Referee 2

The manuscript presents results on the thrust and lateral forces of a laboratory-scale model of a Vertical Axis Wind Turbine (VAWT) tested in a wind-wave basin under parked conditions. Experimental data were compared with a semi-numerical code, which retrieves gravitational loads from the experimental measurements, in several cases: i) fixed-bottom – wind; ii) floating – wind – no waves; iii) floating – wind – waves. The goal of the work was to assess parked loads in relation to design parameters, such as the number of blades and free-stream velocity.

Figure 1: Reduced frequency for different platform and turbine operating conditions. Note: Section Radius refers to the rotor radius, which varies with rotor height.

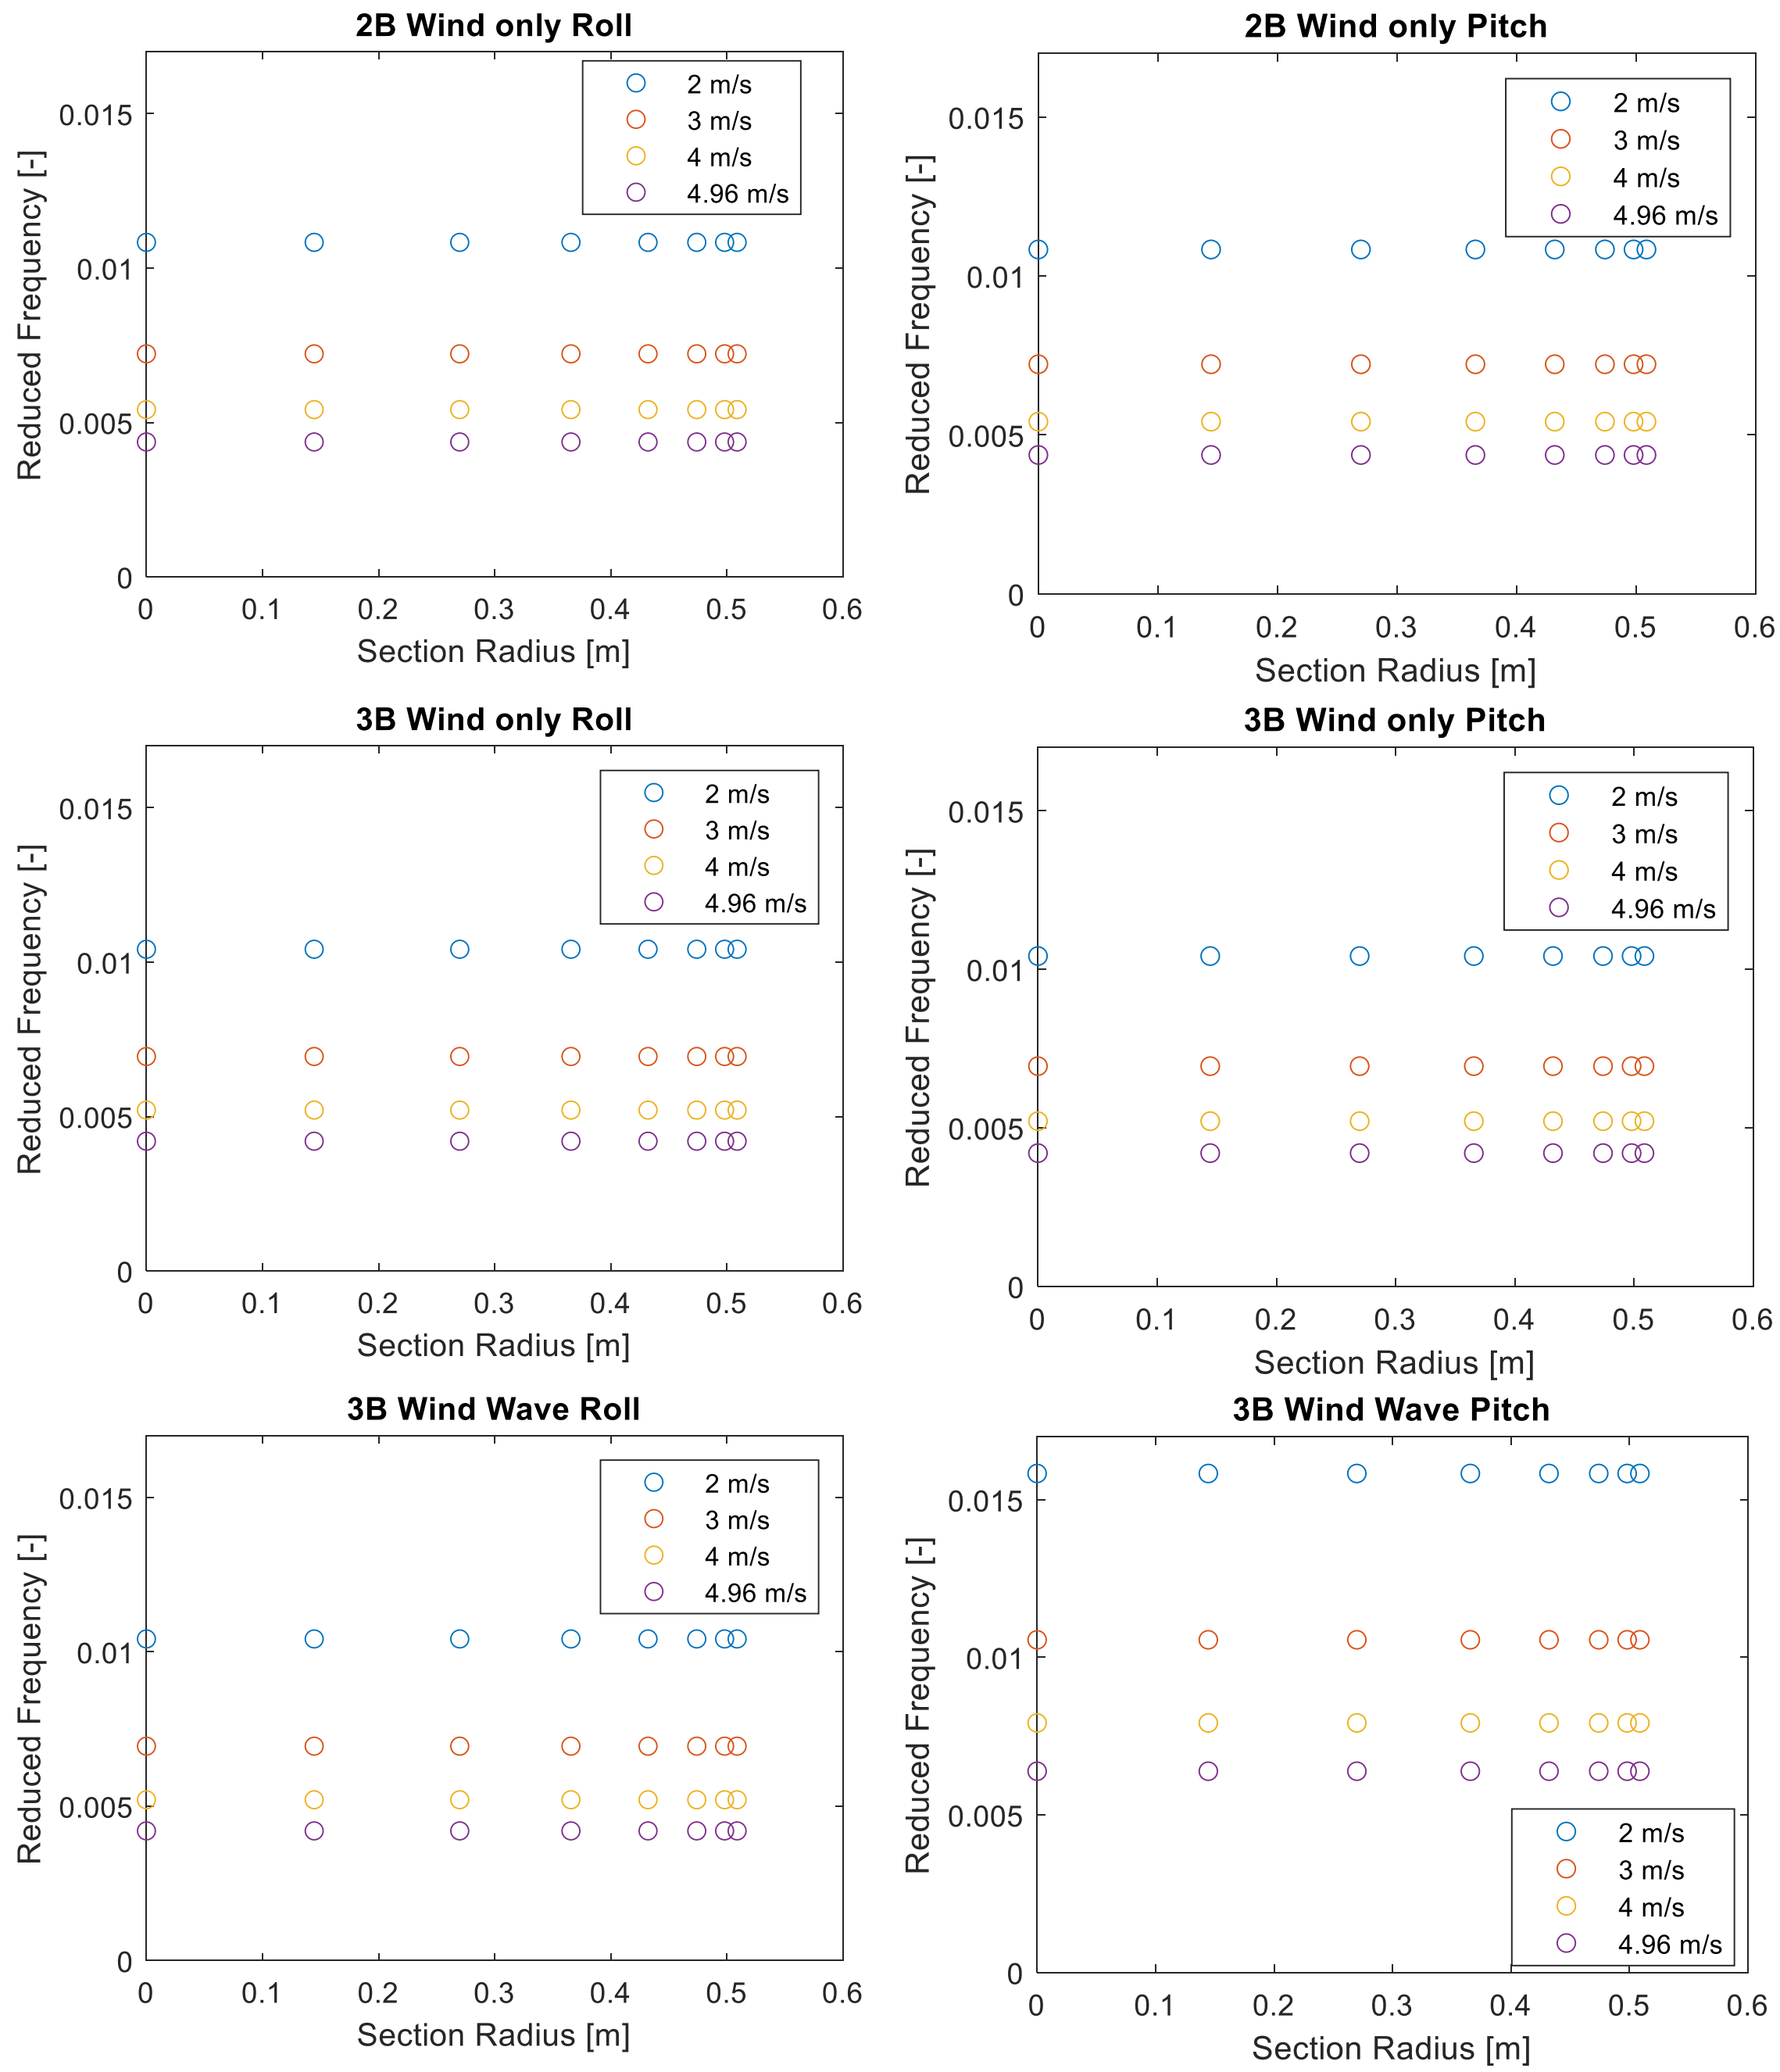
6. Dynamic stall is not considered, nor are unsteady effects in the case of wind and wave excitation. Have the reduced frequencies been evaluated to demonstrate that unsteady aerodynamics does not occur?
   Response: Thanks for the comment. As the turbine is parked, the chance of occurring dynamic stall is very minimal. Therefore, we did not consider the dynamic stall model in the semi-numerical tool.

The authors have analyzed the reduced frequency in the updated manuscript. Reduced frequency is a parameter used to determine whether the inflow is unsteady, and it can be defined as follows [5]:

$$K_i = \frac{\omega_{ptfm}\, C_i}{2\sqrt{(U_\infty^2 + r_i^2 \Omega_\infty^2)}}$$

where, ω_{ptfm} is the platform frequency, C_i is airfoil chord, U_∞ is freestream velocity, r_i is section radius, Ω is rotational velocity of rotor.

Reduced frequency does not go above a value of 0.05 for both floating wind only and floating wind wave condition for any of the wind speeds, as shown in Figure 1. The highest reduced frequency (K) of 0.0158 occurs in the 3B floating wind wave pitch case. As wind speed increases, the reduced frequency decreases. Specifically, for the 3B floating wind wave pitch case, the reduced frequencies (K) at wind speeds of 2, 3, 4, and 4.96 m/s are 0.0158, 0.0105, 0.0079, and 0.0063, respectively. This indicates that higher wind speeds result in a steadier inflow. Therefore, the inflow can be considered as steady. Notes have been added on lines 154-165 to provide this information.

Figure 2: Parked loads with uncertainty of 2B turbine for locked wind only condition.

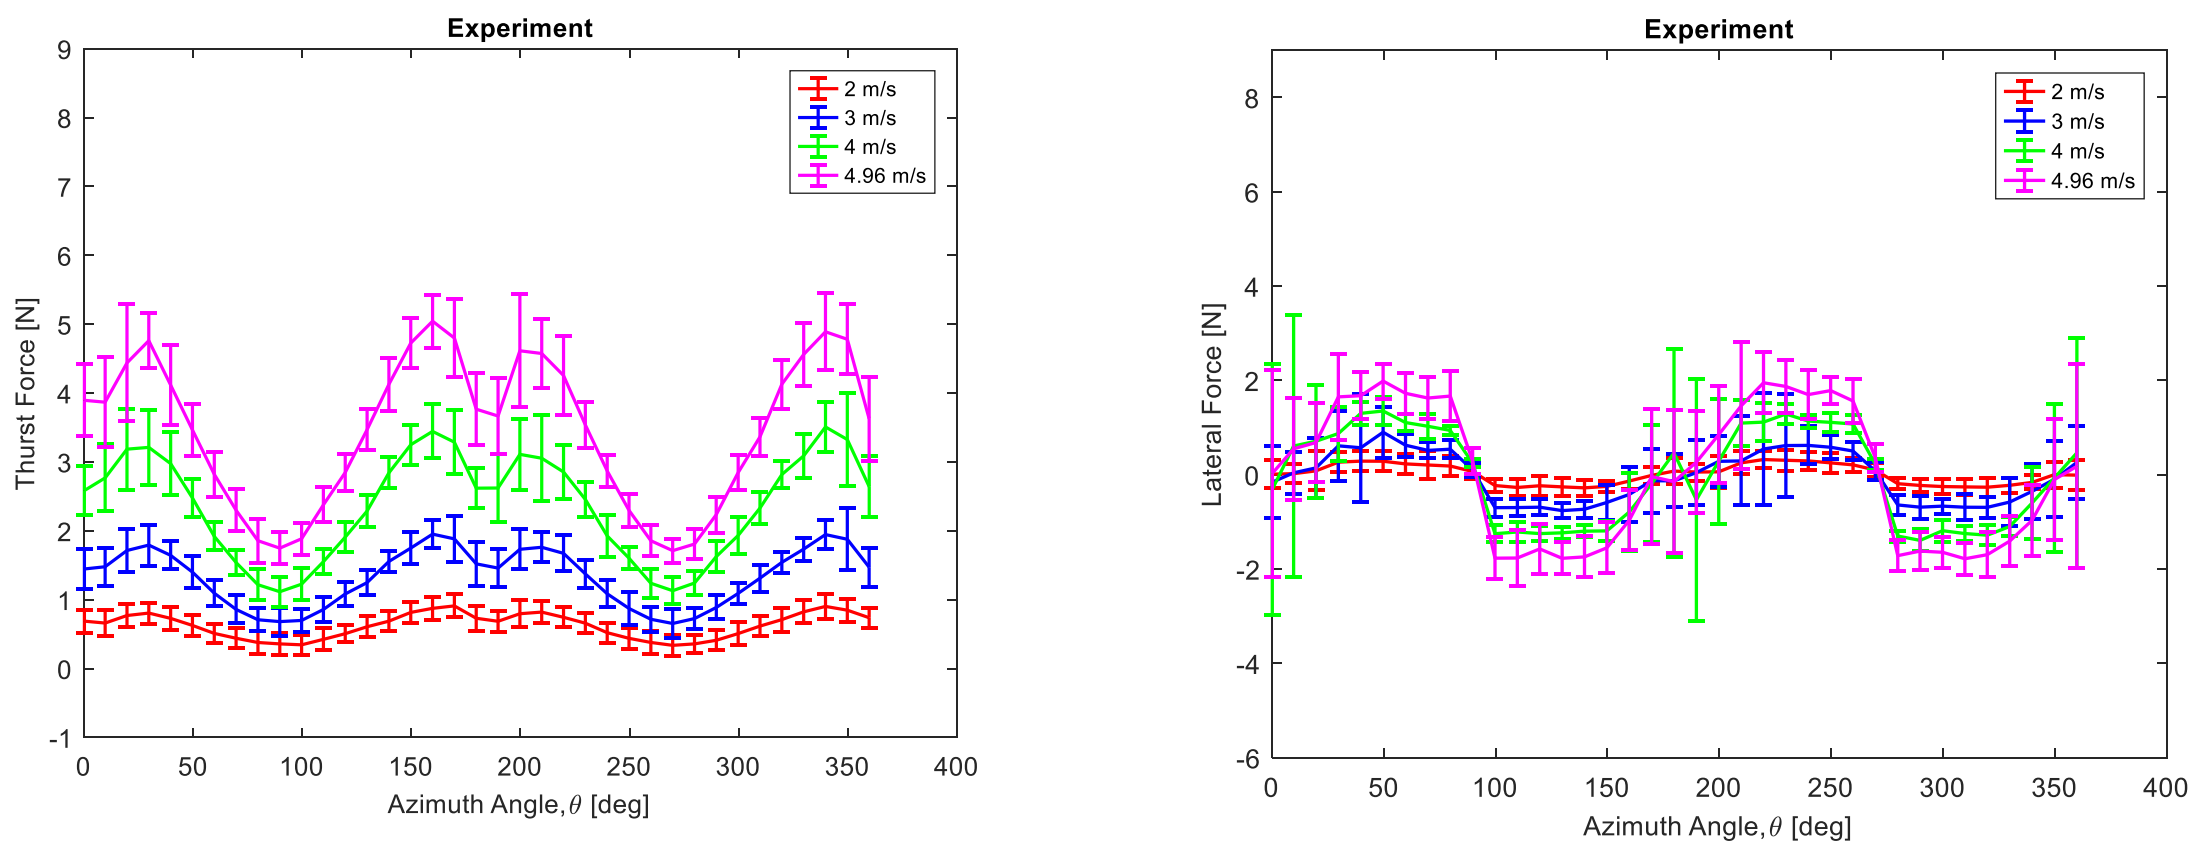
11. A general question regarding experimental data: Have the authors assessed the uncertainty in the measurements?

Response: We have addressed the uncertainty in the measurements; for example, as shown in Figure 2 below and in Figure 8 on page 14 in the revised manuscript. Subsection 3.1.1 has been added to the revised manuscript for presentation of the uncertainty analysis [7]:

$$U = \sqrt{\beta^2 + (\boldsymbol{t\sigma})^2}$$

where, *U* is resultant uncertainty and *t* is the coverage factor of T distribution. The value of *t* is 1.96 at 95% confidence level.
